Subject: P.H.O. APPLICATION NO. PHO-6-26--Z-47-19-7 – Notice of Pending Actions by the **Planning Hearing Officer**

APPLICATION FOR PLANNING HEARING OFFICER ACTION

APPLICATION NO: PHO-6-26--Z-47-19-7

Request For: Stipulation Modification

Z-47-19-7 Conceptual Site Plan

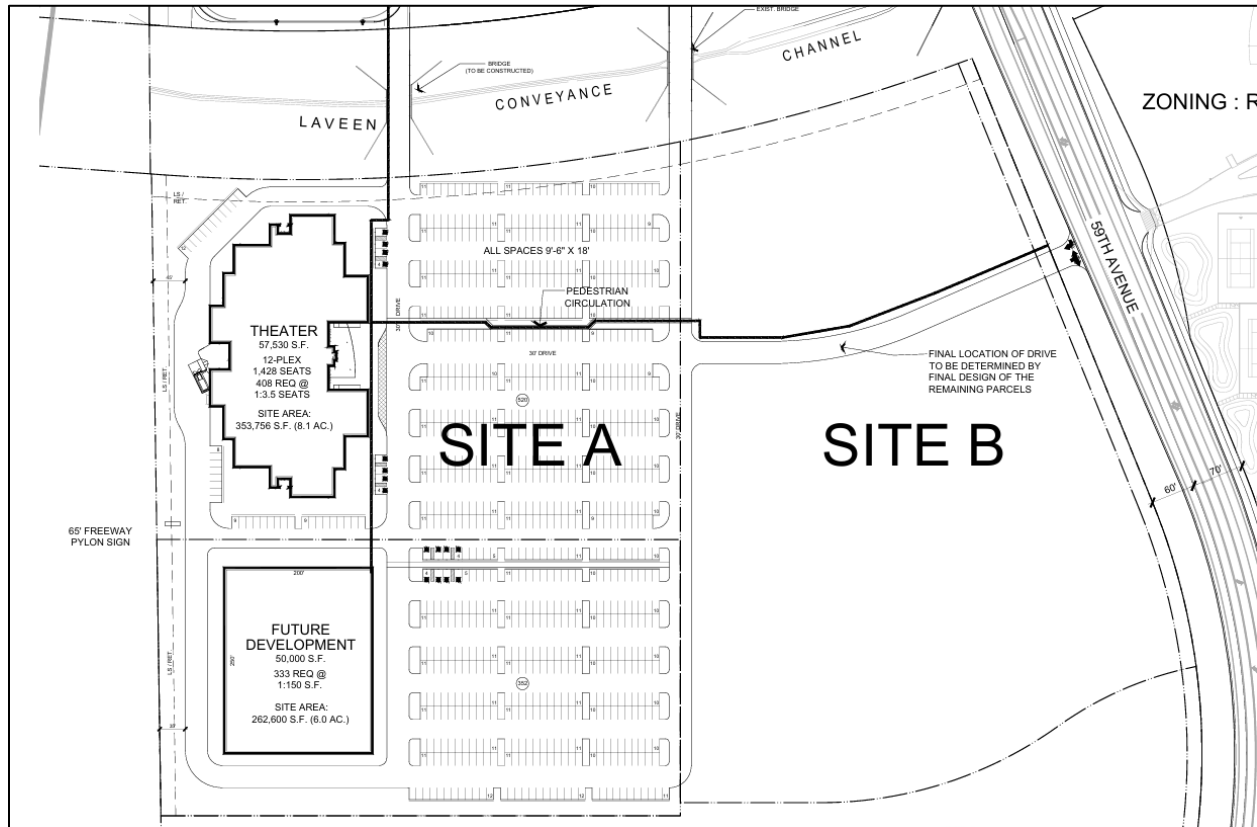
In 2019, the subject property was rezoned to C-2 HGT/WVR as part of a larger 128-acre zoning case. At that time, a conceptual site plan identified the subject parcel (labeled as Sites A and B) as the potential location for a movie theater and a second major tenant on Site A. Due to the operational and design characteristics of a theater, additional building height was requested and approved through the zoning entitlement process. Site B had not yet been conceptually designed.

Proposed Site Plan

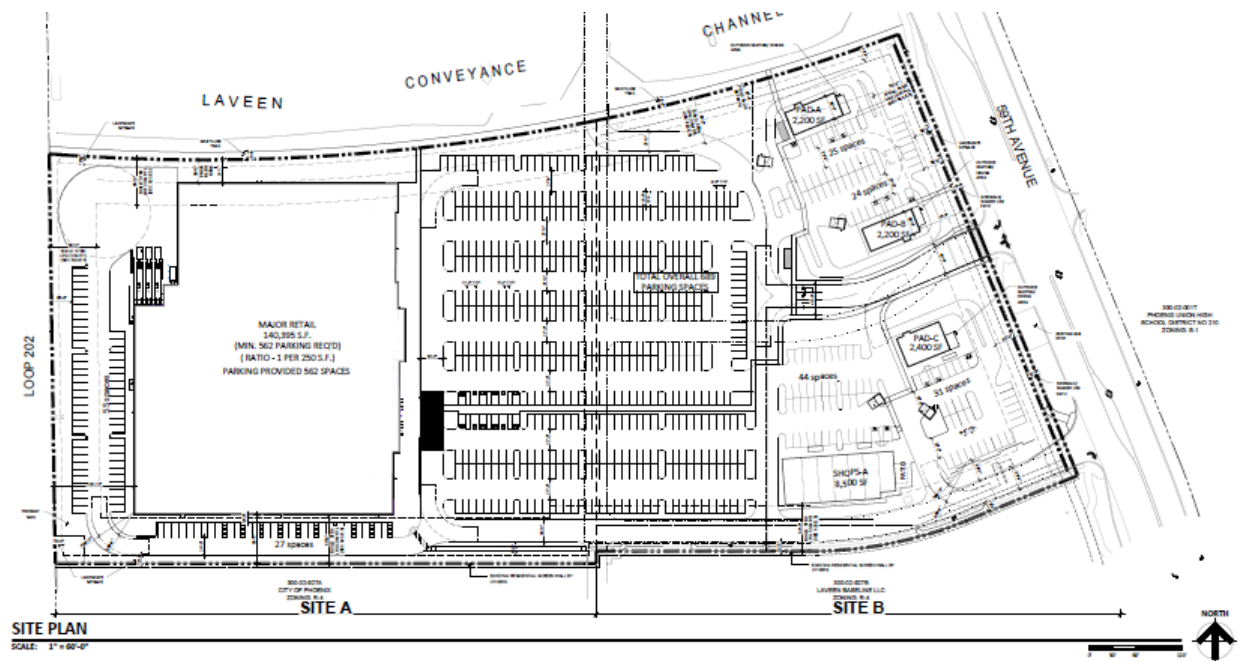
Since the rezoning approval, market conditions have evolved and the previously contemplated movie theater with a second major tenant is no longer proposed for Site A. Instead, the property is planned to be developed with a Target that will serve as an anchor for the commercial center south of the Laveen Area Conveyance Channel. Additionally, four pad sites and a multi-tenant building are contemplated for Site B which could house a future mix of commercial uses.

While the proposed uses remain consistent with the Site's C-2 zoning designation and the commercial vision established for the development the change in the anchor tenant to Target and layout development of Site B necessitates revisions to the approved zoning stipulations. The modifications requested are intended to accommodate the operational requirements and site layout of the proposed Target while maintaining compatibility with the overall development and the

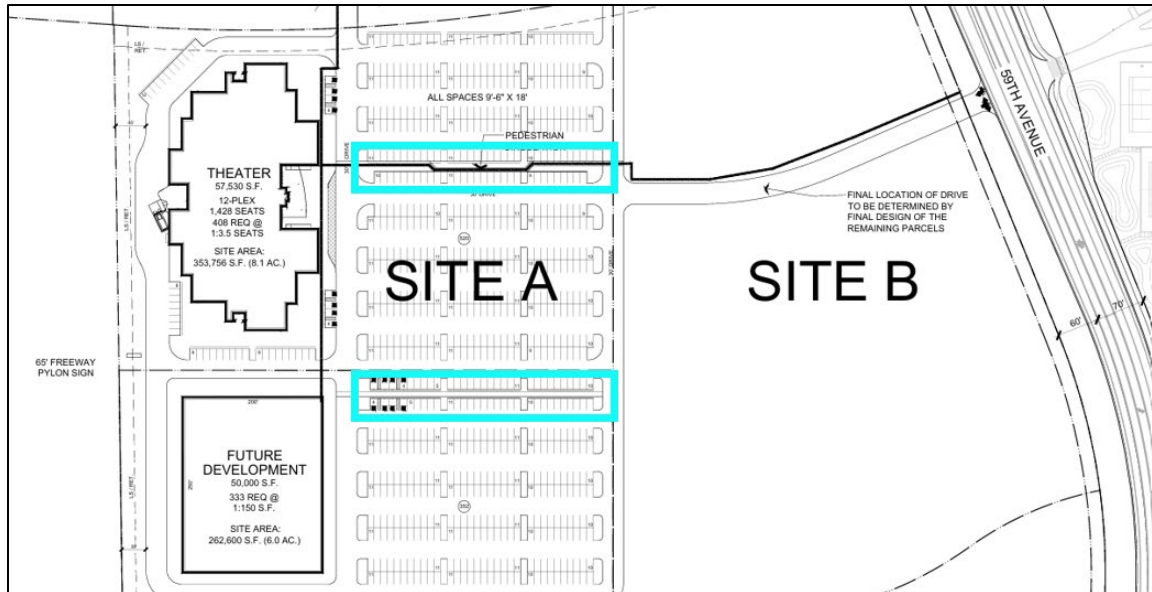
Modification of Stipulation 13 (Z-47-19) and Stipulation 14 (PHO-4-21--Z-47-19) regarding general conformance to the site plan date stamped October 23, 2019.

The development shall be in general conformance with the site plan ~~and elevations~~ date stamped ~~October 23, 2019~~ August 7, 2026 as modified by the following stipulations and approved by the Planning and Development Department.

Rationale: Because the proposed anchor tenant is changing from a movie theater to Target, the movie theater's elevations included in the site plan are no longer applicable. The new proposed conceptual site plan depicts the proposed Target.
